# Access Compliance Report

## Public Rights-of-Way

Intersection ID: 14612	Main Street: ELI_ST	Cross Street: BAXTER_ST	Location: NE
ADA ID: E86FF8C45B89	Ramp Type: PerpDiag	Initial Pass/Fail: Fail	Overall Compliance: No
			Severity Score: 21.25

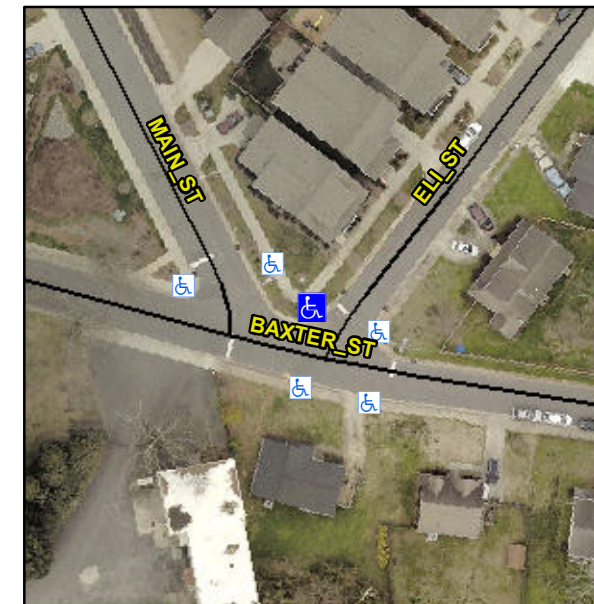
**Not Found, R304.5.1, R304.2.2**

Compliance	Description	Data	Compliance	Description	Data
N/A	Ramp Length (in)	102.0	No	Ramp Slope (%)	9.2
No	Ramp Width (in)	46.0	Yes	Ramp XSlope (%)	1.3
N/A	Flare Type LT	N/A	N/A	Flare Type RT	N/A
N/A	Flare Slope LT (%)	N/A	N/A	Flare Slope RT (%)	N/A
N/A	Flare Traversable LT?	N/A	N/A	Flare Traversable RT?	N/A
N/A	Landing Length (in)	N/A	N/A	DWS Provided?	N/A
N/A	Landing Width (in)	N/A	N/A	DWS Contrast?	N/A
N/A	Landing Slope (%)	N/A	N/A	DWS Length (in)	N/A
N/A	Landing X Slope (%)	N/A	N/A	DWS Full Width?	N/A
N/A	Landing Curb? (Y/N)	N/A	N/A	DWS Offset (in)	N/A
N/A	Shared Landing?	N/A			
N/A	Gutter Ponding?	N/A	N/A	Gutter Slope (%)	N/A
N/A	Gutter Lip Ht (in)	N/A	N/A	Gutter X Slope (%)	N/A
N/A	Painted X Walk1?	No	N/A	Painted X Walk2?	No
	X Walk 1 Direction	To S		X Walk 2 Direction	To SE
N/A	X Walk 1 Width (in)	N/A	N/A	X Walk 2 Width (in)	N/A
	X Walk 1 Slope (%)	2.1		X Walk 2 Slope (%)	0.4
	X Walk 1 X Slope (%)	0.4		X Walk 2 X Slope (%)	1.9

**Remove & Replace Curb Ramp With Two New Directional Ramps or Equivalent.**
